# UNITED STATES PATENT AND TRADEMARK OFFICE

APPLICATION NO.	FILING DATE	FIRST NAMED INVENTOR	ATTORNEY DOCKET NO.	CONFIRMATION NO.
10/708,626	03/16/2004	Kim Kwee Ng		2625

# Office Action Summary

## **DETAILED ACTION**

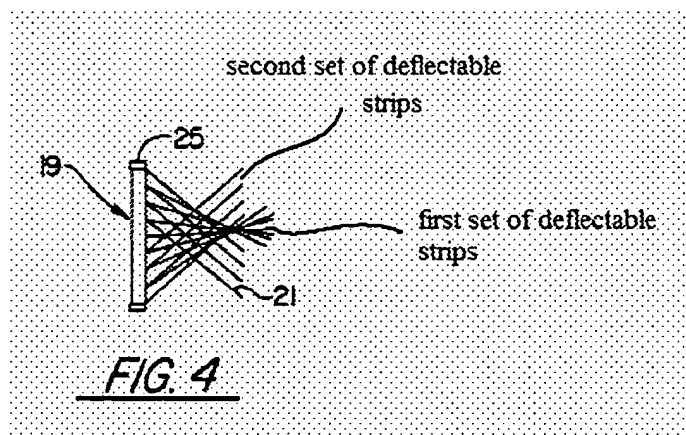
Wilson discloses an insect trap comprising an aperture (at 19), a first set of deflectable strips (i.e. the more interior of the disclosed strips at 21, as seen at the right), an enclosure for surrounding the crawl path (24) and an insect attractant (17) wherein the insect enters the aperture and deflects the strips which then return to a closed position once the insect has departed the strips (column 2, lines 4-7)

Regarding claim 42, Wilson discloses the enclosure comprises a second set of a plurality of deflectable strips (i.e. the more exterior of the disclosed strips at 21, as seen in the Figure above).
